Supersedes:
E8361A-02A

E8361A PNA Series RF Network Analyzers

Serial Numbers: 00000000 thru 46999999

July 26, 20077

Figure 1

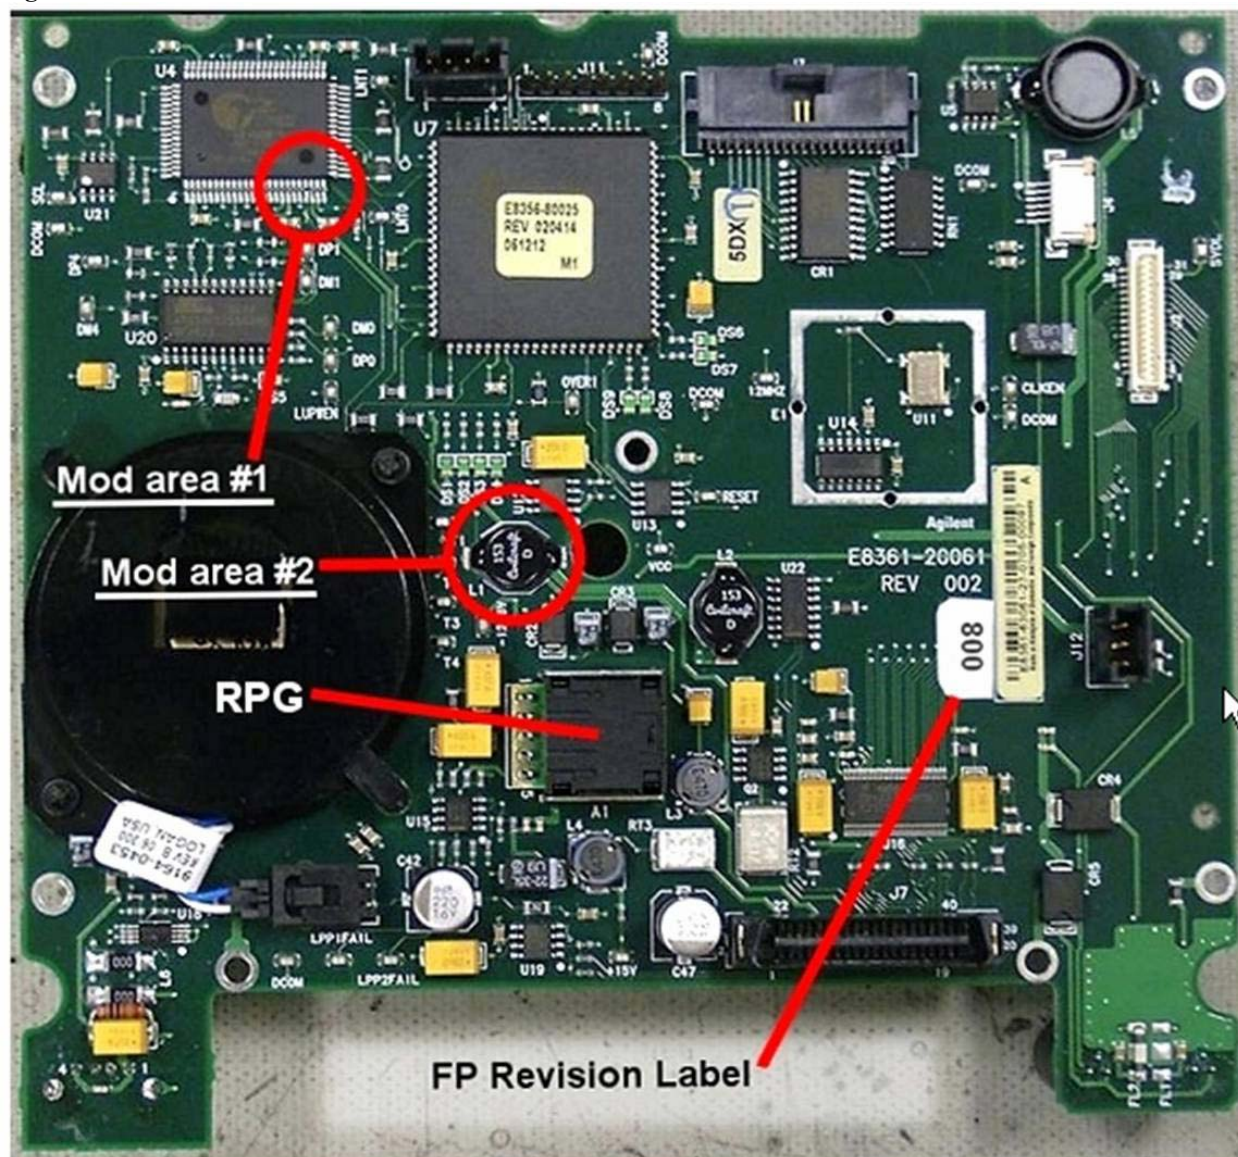
Refer to Figure 1 for the two modification areas to be addressed. Note that while this picture happens to show the FPA board completely removed from the front frame assembly, this is not necessary to perform the required modifications.

- Modification #1 consists of shorting two pins of U4 together with a small amount of solder.
- Modification #2 consist of removing L1.

Unsolder and completely remove the black surface mount inductor L1 from the front panel assembly board. This is no longer needed and can be discarded.

Figure 2

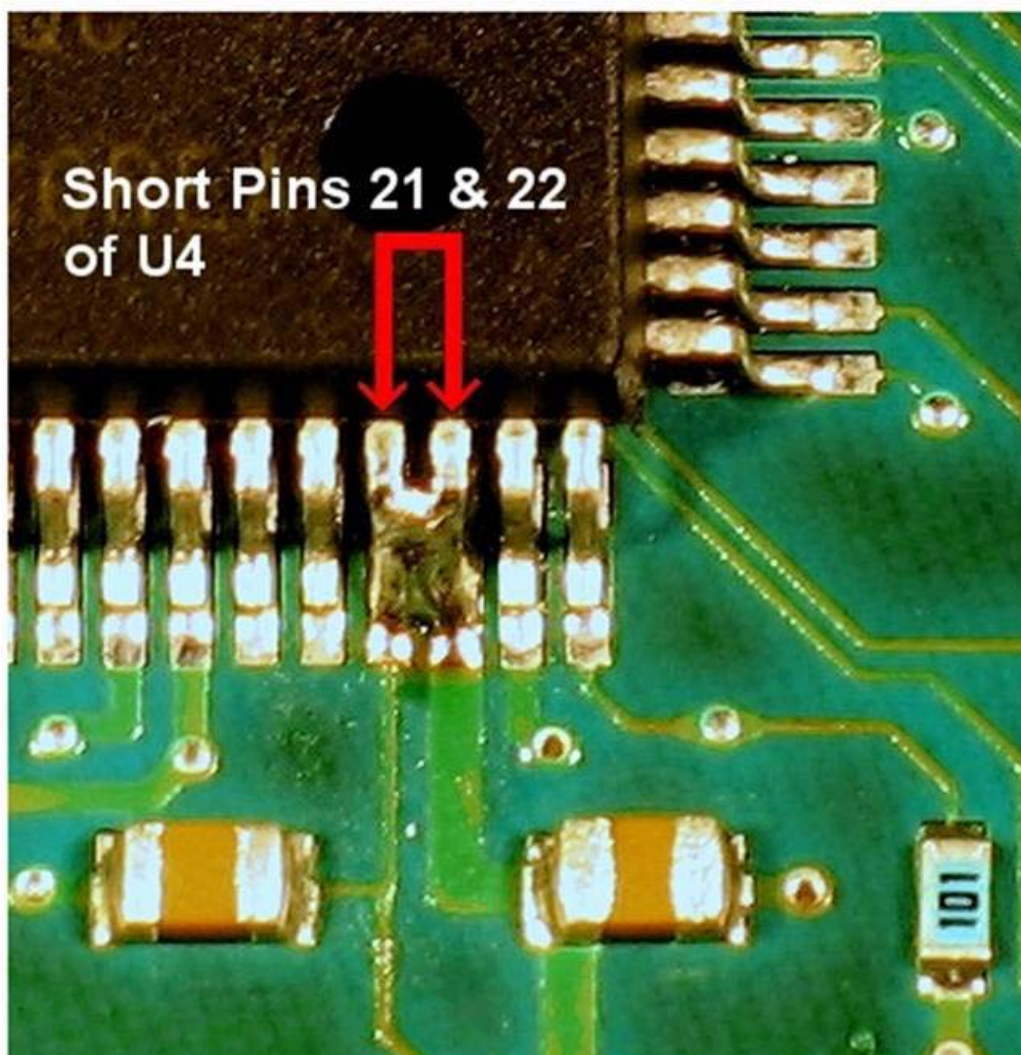
Modification #1

Carefully solder pins 21 and 22 together on U4. Refer to Figure 2 for the exact location. Use care so that no other pins are shorted. Use of a very fine tip soldering iron is recommended and a large work-task magnifying glass is very helpful.
